Access Compliance Report Public Rights-of-Way (Curb Ramps)

Main Street: EPONA_WAY Cross Street: COPIOUS_LN Location: E

ADA ID: RPRK211027142801 Ramp Type: Type 4 - Parallel Initial Pass/Fail: Pass Overall Compliance: No Severity Score: 20

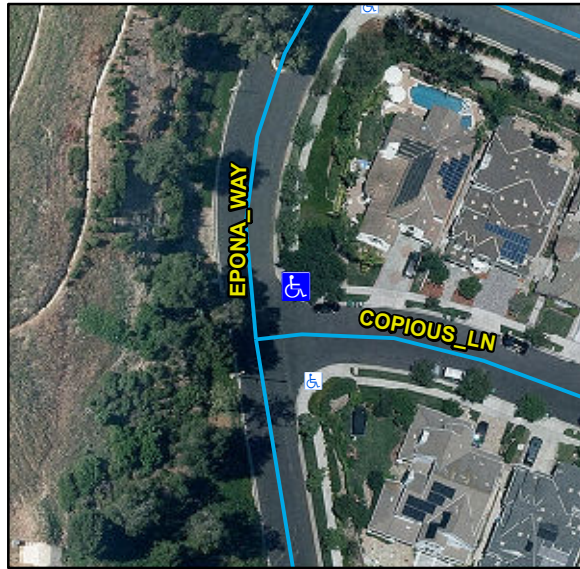
Compliance	Description	Data	Compliance	Description	Data
N/A	Ramp Length LT (in)	137	N/A	Ramp Length RT (in)	138
Yes	Ramp Width LT (in)	53	Yes	Ramp Width RT (in)	53
Yes	Ramp Run Slope LT (%)	8.2	Yes	Ramp Run Slope RT (%)	2
Yes	Ramp Cross Slope LT (%)	0.9	Yes	Ramp Cross Slope RT (%)	1.3
N/A	Landing Present	No	No	DWS Provided	No
N/A	Landing Length (in)	N/A	N/A	DWS Contrast	N/A
No	Landing Width (in)	N/A	N/A	DWS Length (in)	N/A
No	Landing Run Slope (%)	N/A	N/A	DWS Full Width	N/A
No	Landing Cross Slope (%)	N/A		DWS Offset Type	N/A
N/A	Landing Movement Obstructed?	No	N/A	DWS Offset Left (in)	N/A
	Landing Movement Type	Curb	N/A	DWS Offset Right (in)	N/A
N/A	Landing Shared	N/A			
N/A	Clear Space	Yes			
N/A	Clear Space To Crosswalk (in)	48			
N/A	Marked Crosswalk 1	No	N/A	Marked Crosswalk 2	No
	Crossing 1 Direction	NW		Crossing 2 Direction	SW
	Marked Crosswalk 1 Width (in)	N/A		Marked Crosswalk 2 Width (in)	N/A
N/A	Ramp Inside Crosswalk 1	N/A	N/A	Ramp Inside Crosswalk 2	N/A

Crossing 1 Slope (%)	3.4		Crossing 2 Slope (%)	1.7
	Crossing 1 Cross Slope (%)	1.6		Crossing 2 Cross Slope (%)	2.4
Yes	Gutter Ponding	No	No	Curb Slope	8.4
Yes	Gutter Lip Height (in)	0		Road Run Slope (%)	2.3
Yes	Gutter Run Slope (%)	4.9		Road Cross Slope (%)	5.1
No	Gutter Cross Slope (%)	4.2	No	Perpendicular Joint Present	No
Yes	Overall Surface Condition	Acceptable			
	Cross Gutter Present?	No		Spandrel Present?	No
	Replace Cross Gutter?	N/A		Replace Spandrel?	N/A

Remove & Replace Curb Ramp With Two New Directional Ramps or Equivalent. Remove & Replace Gutter.
